Project	IEEE 802.16 Broadband Wireless Access Working Group < http://ieee802.org/16 >	
Title	Bandwidth Request for Distributed Systems	
Date Submitted	2007-01-08	
Source(s)	Okuda Masato and Yuefeng Zhou Fujitsu	okuda@jp.fujitsu.com Yuefeng.Zhou@uk.fujitsu.com
Re:	IEEE802.16j-06/027: "Call for Technical Proposals regarding IEEE802.16j"	
Abstract	This contribution proposes a distributed bandwidth request and allocation mechanism.	
Purpose	To propose text to describe a distributed bandwidth request and allocation mechanism	
Notice	This document has been prepared to assist IEEE 802.16. It is offered as a basis for discussion and is not binding on the contributing individual(s) or organization(s). The material in this document is subject to change in form and content after further study. The contributor(s) reserve(s) the right to add, amend or withdraw material contained herein.	
Release	The contributor grants a free, irrevocable license to the IEEE to incorporate material contained in this contribution, and any modifications thereof, in the creation of an IEEE Standards publication; to copyright in the IEEE's name any IEEE Standards publication even though it may include portions of th

Figure X-1 Extended MAC Signaling Header Type II Format

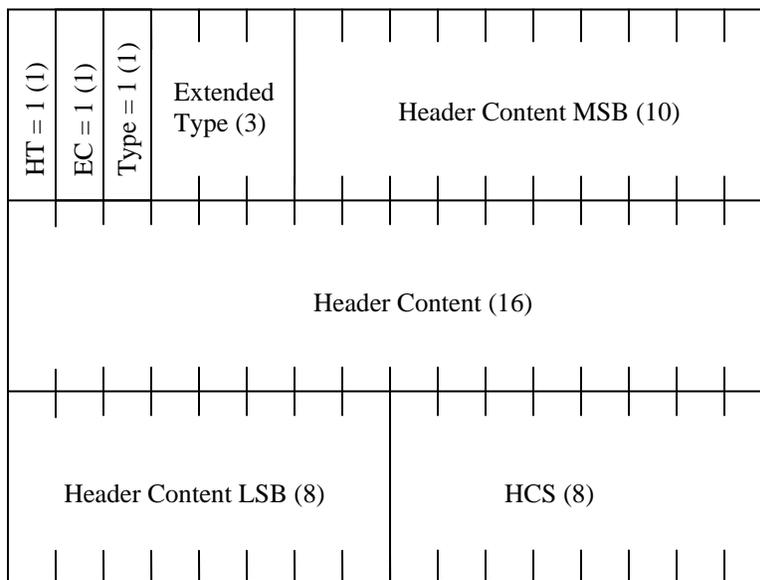
[Insert the following subclause at the end of 6.3.2.1.2.2:]

6.3.2.1.2.2.2 Extended MAC Signaling Header Type II

This type of MAC header is UL specific. There is no payload following the MAC header. The Extended MAC signaling header type II is illustrated in Figure X-1. Table X-1 describes the encoding of the 3-bit extended type field following the type field.

Figure X-1 Relay Bandwidth Request Header Format

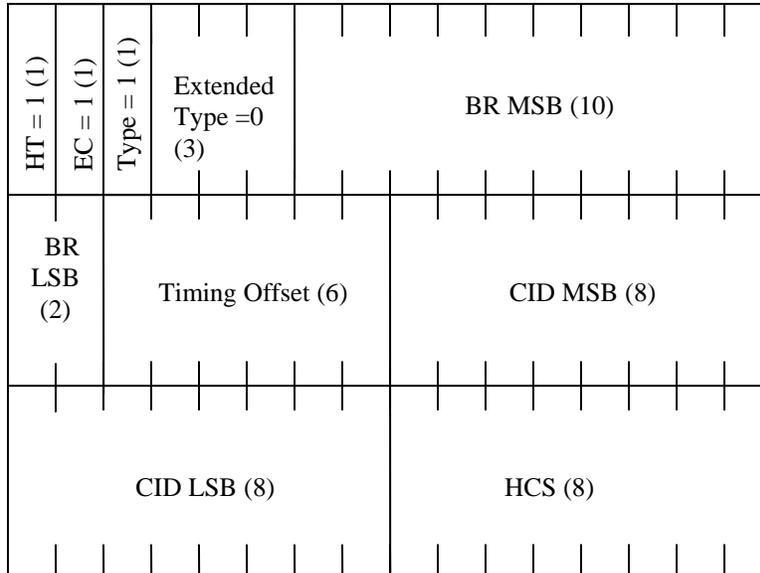
6.3.2.1.2.2.2.1 Relay Bandwidth Request Header

The Relay Bandwidth Request header is sent by an RS to request bandwidth on the relay uplink to its upstream MR-BS or RS. In addition to the bandwidth request itself, the Relay Bandwidth Request Header includes timing offset information that indicates at what time this bandwidth allocation is requested. The RS or MR-BS receiving the header shall wait a period of time equal to the timing offset before allocating bandwidth on the relay uplink to the downstream RS.

Name	Size	Description
<u>BR</u>	<u>12 bits</u>	<u>Bandwidth Request: The number of bytes of uplink bandwidth requested by the RS. The bandwidth request is for the CID. The request shall not include any PHY overhead. It</u>
<u>Timing Offset</u>	<u>6 bits</u>	<u>Time (in units of a frame) the receiver shall wait before allocating bandwidth corresponding to this header.</u>
<u>CID</u>	<u>16 bits</u>	<u>The CID shall indicate the connection for which uplink bandwidth is requested.</u>
<u>HCS</u>	<u>8 bits</u>	<u>Header Check Sequence (same usage as HCS entry in Table 5).</u>
